Consensus Discussion: CM noise and return loss

P802.3ck Chief Editor

Introduction

Graph from ghiasi_3ck_03a_0720.

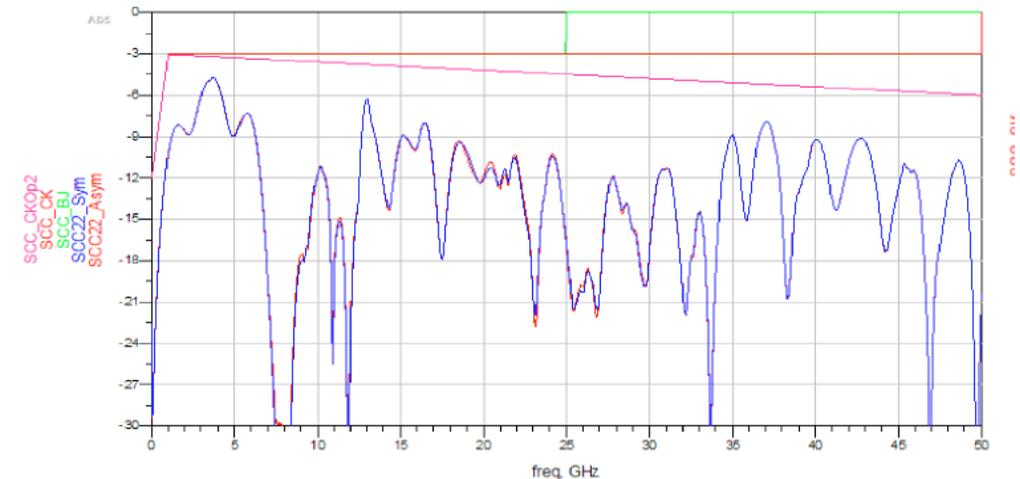
CI 120G	SC 120G.3.2	P 224	L 52	# 208
Ghiasi, Ali		Ghiasi Quantum/Inphi		
Comment Type	TR	Comment Status	D	
Unless one end of the link has common mode termination the 17.5 mV allowed common mode does not get absorbed				
SuggestedRemedy				
Add common mode return loss with following equation = $12 - 9*f/1e9$ dB up to 1 GHz 3 dB from 1GHz to 50 GHz See ghiasi_03_0620				
Proposed Response	Response Status W			
PROPOSED ACCEPT IN PRINCIPLE				
[Editor's note: ch:				
CI 120G	SC 120G.3.1	P 221	L 23	# 207
Ghiasi, Ali		Ghiasi Quantum/Inphi

Comment Type	TR	Comment Status	D	
Unless one end of the link has common mode termination the 17.5 mV allowed common mode does not get absorbed				
SuggestedRemedy				
Add common mode return loss with following equation = $12 - 9*f/1e9$ dB up to 1 GHz 3 dB from 1GHz to 50 GHz See ghiasi_03_0620				
Proposed Response	Response Status W			
PROPOSED ACCEPT IN PRINCIPLE				
[Editor's note: changed subclause from 120G.3.]				
Pending review of the following presentation: http://www.ieee802.org/3/ck/public/20_07/ghiasi_3ck_03_0720.pdf				
As the commenter points out, common-mode return loss is not specified for either the module output or the host input.				
Use 0.01 GHz for the low frequency limit.				
For task force discussion.				
Resolve with #208.

Comments 208 and 207 propose limits for C2M host/module output:
 $RLCC(f) \geq \dots$
 $12 - 9*f/1e9$ dB, $f =$ up to 1GHz
 3 dB, $f =$ 1GHz to 50 GHz
 Lower should be limit be 0.01 GHz.
 Upper limit should be 53.125 GHz to match other specs in 120G.

Potential response:
 PROPOSED ACCEPT IN PRINCIPAL
 In 120G.3.2 and 120G.3.1, specify RLCC as follows:
 $RLCC(f) \geq \dots$
 $12 - 9*f/1e9$ dB, $f =$ 0.01 GHz to 1 GHz
 3 dB, $f =$ 1 GHz to 53.125 GHz
 Implement with editorial license.
